TITLE MP Printer Cassette, Continuous Heatshrink Tubing				
CUSTOMER DRAWING				
ITEM REVISION NAME 100743XS/04		PANDUIT		
DATASET FILE NAME 100743XS_DC/04A MP HST TUBE CUST DWG				
UNLESS OTHERWISE SPECIFIED, DIMENSIONAL TOLERANCES ARE: IN [mm] .x ± .1 [2.54] .xxx ± .025 [.635] .xx ± .05 [1.27] ANGLES ±			MATERIAL: SEE TABLE	
DRAWING NUMBER: 100743XS_DC				
DRAWN BY JSUN	DATE 4/21/2020	CHK RKB	SCALE NTS	SHT 1 OF 1
				SIZE A

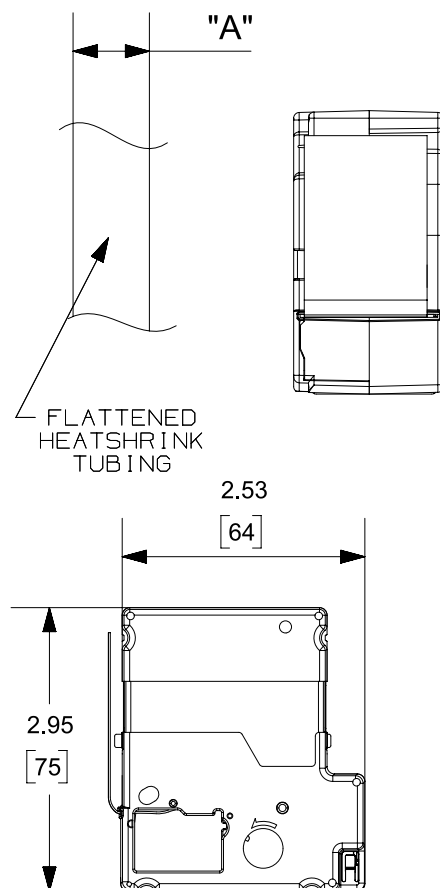
04A	1/17/2025	RVU	JSUN	MSAD	D. DIA. RANGE MIN-MAX, .043-.13 [1.1-3.4] WAS .055-.15 [1.4-3.8]. C. TUBING WIDTH, .26 [6.6] WAS .27 [6.8]. B. PART DESCRIPTION, 24-16 WAS 22-16. A. H00X025H1M, & H2M: MATERIAL, GMHS31ET WAS GMHS31E.	GAECN07224
03B	7/5/2023	RVU	JSUN	MSAD	B. ADDED MP75, MP100, MP200 & MP300 TO TABLE. A. ADDED COMPATIBLE PRINTERS COLUMN TO TABLE.	GAECN06834
03	8/26/2021	JSUN	MSAD	BRJO	ADD 3:1 AND 2:1 SHRINK RATIO TO PART DESCRIPTION	080136/03
0	4/21/2020	JSUN	RGB	RGB	DRAWING RELEASE.	080136/00
REV	DATE	BY	CHK	APR	DESCRIPTION	ECN
